Access Compliance Report Public Rights-of-Way (Curb Ramps)

Main Street: WEATHERBY_RD Cross Street: ROSSMOOR_WAY Location: SW

ADA ID: RPRK211217131551 Ramp Type: Type 1 - Perpendicular Diagonal Initial Pass/Fail: Fail Overall Compliance: No Severity Score: 15

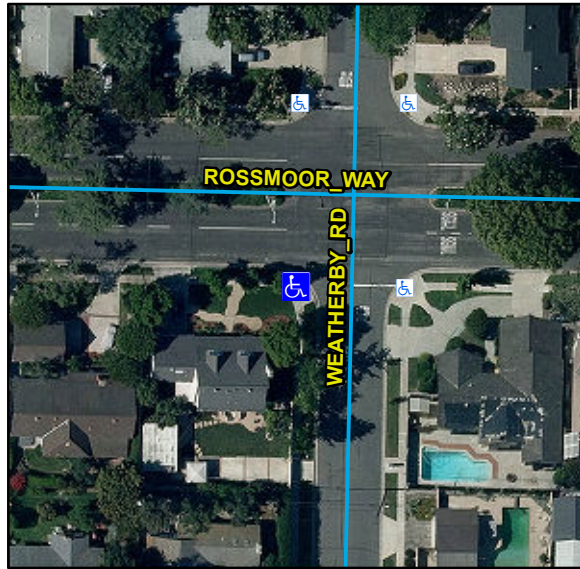
Compliance	Description	Data	Compliance	Description	Data
N/A	Ramp Length (in)	85	N/A	Flare Type LT	
Yes	Ramp Width (in)	48			N/A
No	Ramp Run Slope (%)	9.1	N/A	Flare Slope LT (%)	N/A
Yes	Ramp Cross Slope (%)	0.6	N/A	Flare Traversable LT	N/A
N/A	Landing Present	N/A	N/A	Flare Type RT	
N/A	Landing Length (in)	N/A			N/A
N/A	Landing Width (in)	N/A	N/A	Flare Slope RT (%)	N/A
N/A	Landing Run Slope (%)	N/A	N/A	Flare Traversable RT	N/A
N/A	Landing Cross Slope (%)	N/A	N/A	DWS Provided	N/A
N/A	Landing Movement Obstructed?	N/A	N/A	DWS Contrast	N/A
	Landing Movement Type	N/A	N/A	DWS Length (in)	N/A
N/A	Landing Shared	N/A	N/A	DWS Full Width	N/A
N/A	Clear Space	Yes	N/A	DWS Offset Left (in)	N/A
N/A	Clear Space To Crosswalk (in)	N/A	N/A	DWS Offset Right (in)	N/A
N/A	Marked Crosswalk 1	No	N/A	Marked Crosswalk 2	No
	Crossing 1 Direction	E		Crossing 2 Direction	N
	Marked Crosswalk 1 Width (in)	N/A		Marked Crosswalk 2 Width (in)	N/A

Remove & Replace Curb Ramp With Two New Directional Ramps or Equivalent.
